Issue-01

05th May 2026

Danys Knit wear Limited (Extension)

Surabari, Kashimpur, Gazipur Sadar, Gazipur

Observation-01: Non-engineered structure – inadequate member size, poor connection details, deflected and sagged members. [Shed-01]

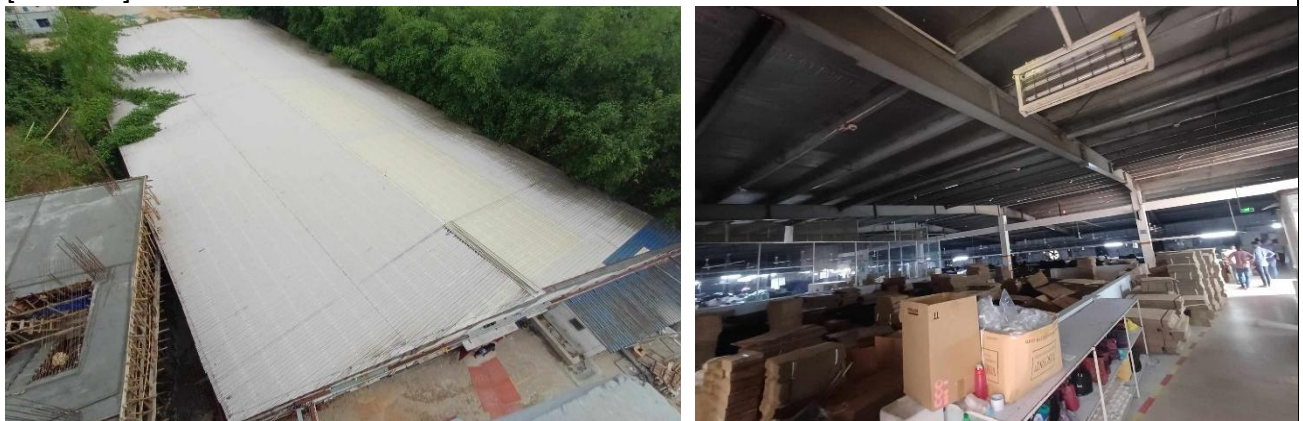
Description: At the time of inspection, non-engineered structural system including inadequate member size, poor connection details, deflected and sagged members were observed for the mentioned structures.

- 1) Building engineer is required to carry out Engineering Assessment (EA) to check for the member adequacy and connection details against lateral and vertical loading.
- 2) The building engineer is required to investigate the sagged and deflected members and carry out the required remedial works.

Observation-03: Lack of design report and stability system in the long direction at periphery. [Shed-02]

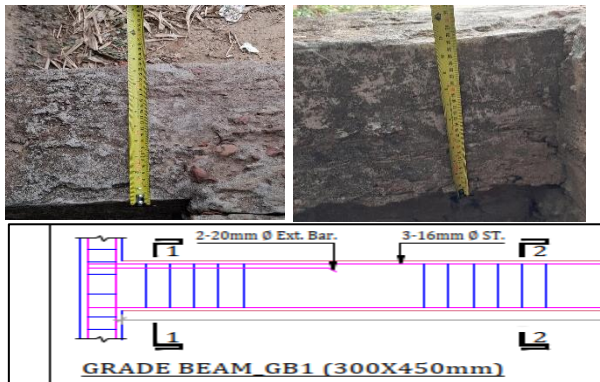
Description: Every building or structure designed shall have its design documents prepared in accordance with the provision of Section 1.9.1. The design document shall include a design report, and a set of structural drawings, which shall be prepared in compliance with section 1.9.1.1 & section 1.9.1.2 of BNBC (part-6).

At the time of inspection, no design report was available for captioned structure. Also, tie beam was missing in the long direction for RC columns at periphery. The building engineer is required to check the structure and prepare a set of design documents in compliance with BNBC and submit to RSC for detailed review.

Observation-04: Mismatch and lack of information in the as-built drawings. [Shed-02]

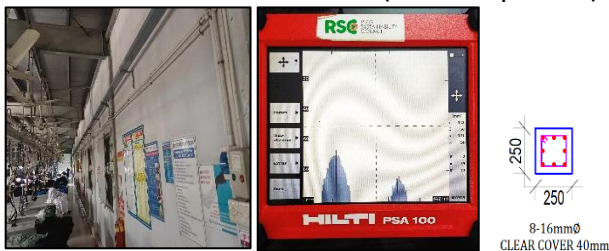
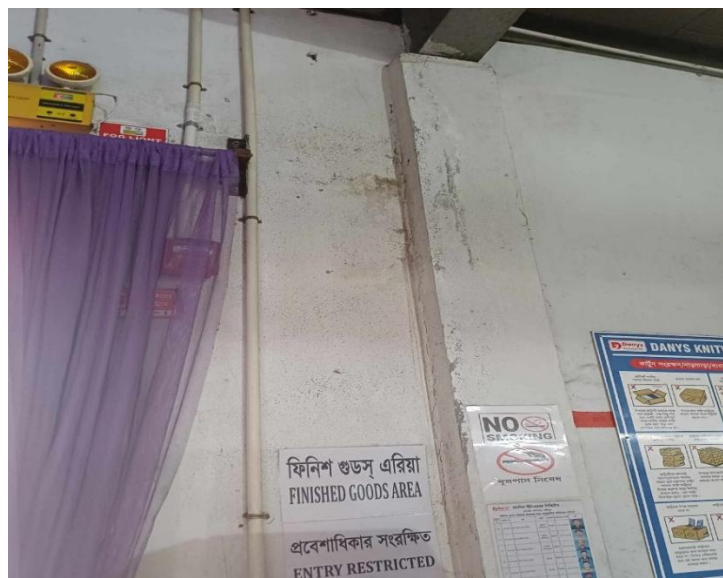
GB size found 240X270mm (without plaster)

Peripheral column re-bar profile found 2/3 instead of 3/3

Lack information in the structural drawing for the toilet part and Spot removing shed

Description: At the time of inspection, mismatch and lack of information were observed the structure.

The building engineer is required to survey the whole structure and update the as-built drawings reflecting the on-site condition.

Observation-06: Connection gap in the rafters. [Shed-02]

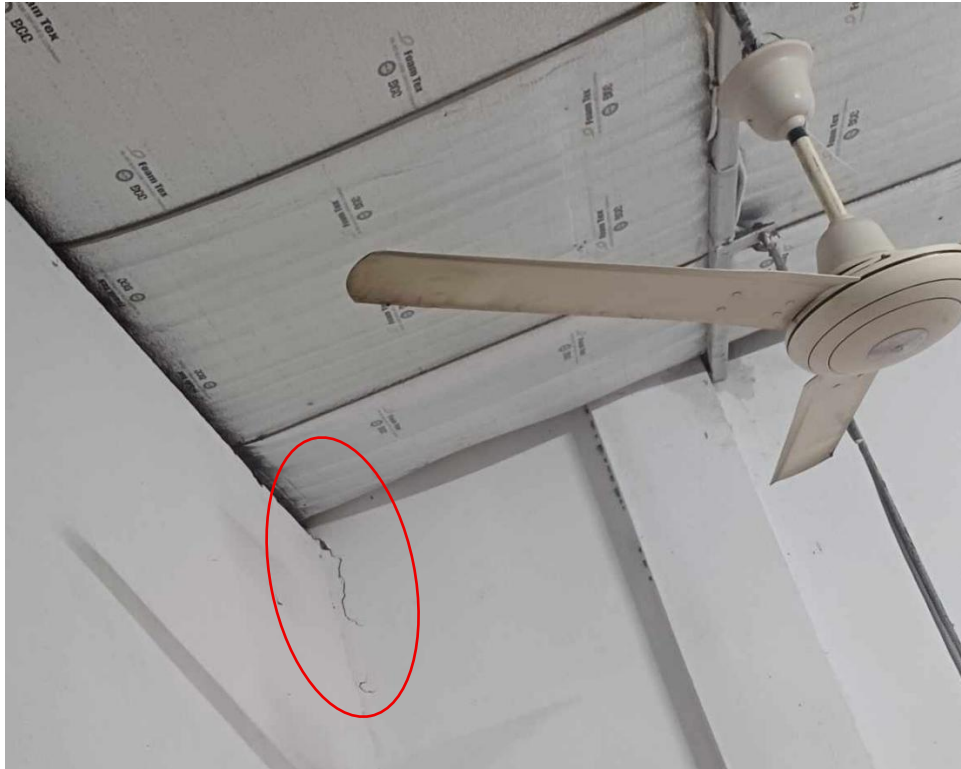
Description: At the time of inspection, connection gaps were observed on the rafters. The factory is required to fill the connection gap with a suitable method.

UGWR top slab

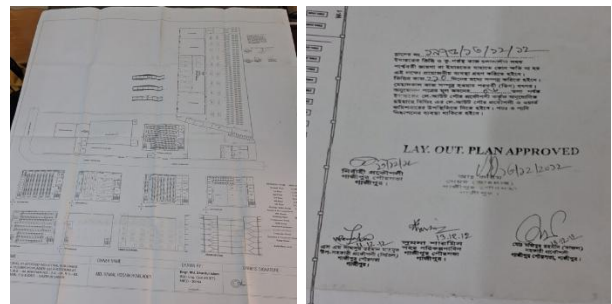
Description: Every building or structure designed shall have its design documents prepared in accordance with the provision of Section 1.9.1. The design document shall include a design report, and a set of structural drawings, which shall be prepared in compliance with section 1.9.1.1 & section 1.9.1.2 of BNBC (part-6).

Parking was observed on the ground slab of the pump room and underground water reservoir. At the time of inspection, no design report was available for the captioned structure. The building engineer is required to prepare a set of design documents including floor load plan for parking zone in compliance with BNBC and submit to RSC for detailed review.
